Re: Andrew and Gladys Keating P1156-01

I refer to previous Agency correspondence of 13^{th} December last. Please find detailed below the response to the issues raised.

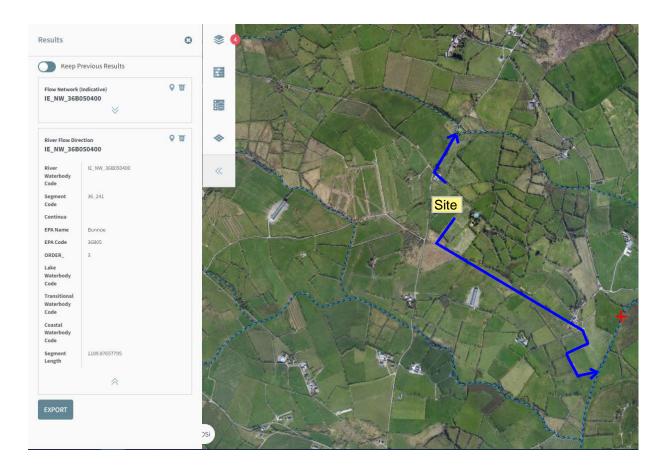
3. Update the site plan to show the locations of the natural gas tanks.

- 4. Stormwater drainage:
 - a. What is the proposed receiving water for SW-3?
 - b. Update the site plan to include the locations of the stormwater discharge points.
 - c. Indicate the flow pathway between the stormwater discharge points and the receiving waters.

Please refer to updated Site Plan enclosed.

Please refer to updated Site Plan enclosed. Please note no discharge to ground currently proposed. All storm water to discharge to a tributary(s) of the Bunnoe River.
